Mekong River Commission
Cambodia • Lao PDR • Thailand • Viet Nam
For sustainable development

TECHNICAL REVIEW REPORT

Prior Consultation for the Proposed Pak Beng Hydropower Project

Prepared by the **Mekong River Commission Secretariat**
June 2017

Figure 5.1 Computed water levels for different discharges, with and without the PBHPP, obtained from model runs in ISH0306 study of MRC (Delft3D model). The results in this figure are indicative.

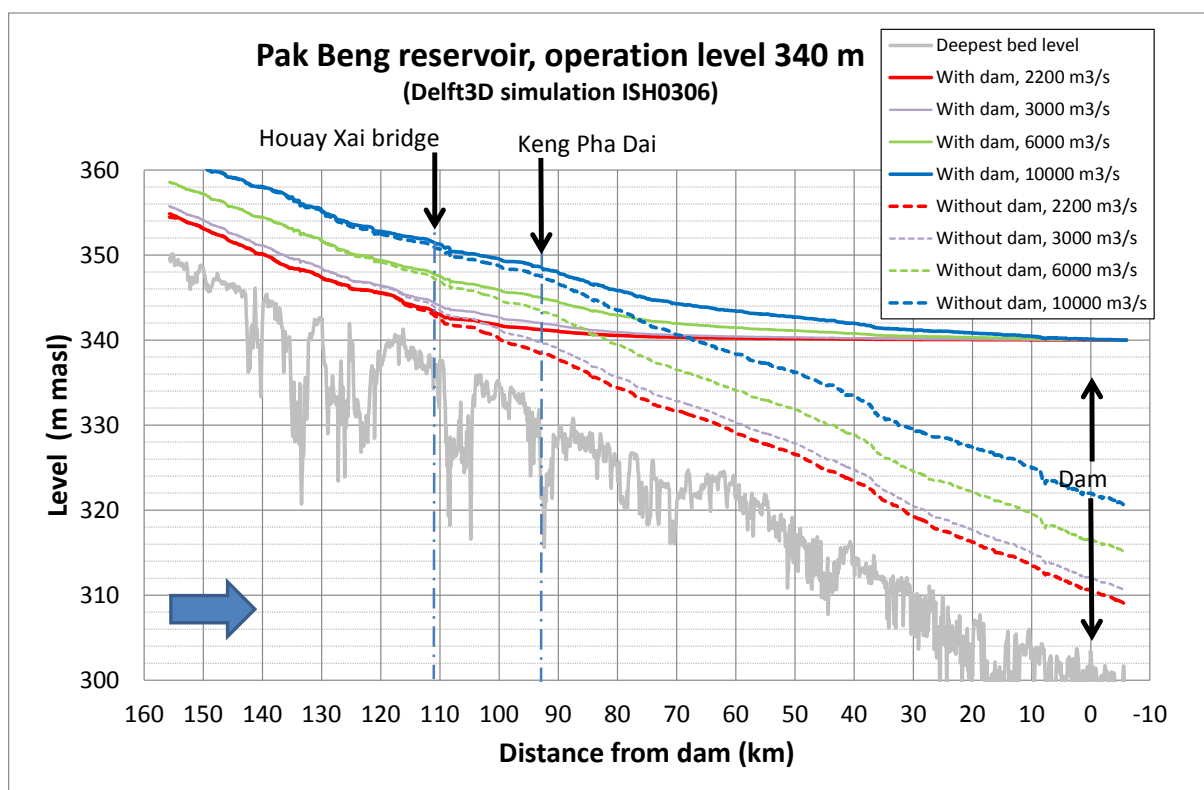
that is caused by the dam operation. The results in Figure 5.1 show that at flows of 2,200 m³/s, the operation of the PBHPP at 340 m can result in a water level increase in the order of 2 m near Keng Pha Dai, and a gradually decline of this increase upstream towards Houay Xai. These increased backwater levels are not as marked at higher flows.

Figure 5.1 does not present the results of the operation of the PBHPP at 335 m, and there is insufficient information to assess whether the operational rules will effectively reduce flooding in Thailand, or whether any cropland or villages will be threatened, including in the tributaries. 2D models are considered to be more suitable for simulating the extent of inundated zones along the banks/flood plains during high flows in the reach affected by the backwater. This includes the lower areas of tributaries that will be affected by the backwater at their mouth. 2D modelling is also required to demonstrate what infrastructure or fields may be inundated.
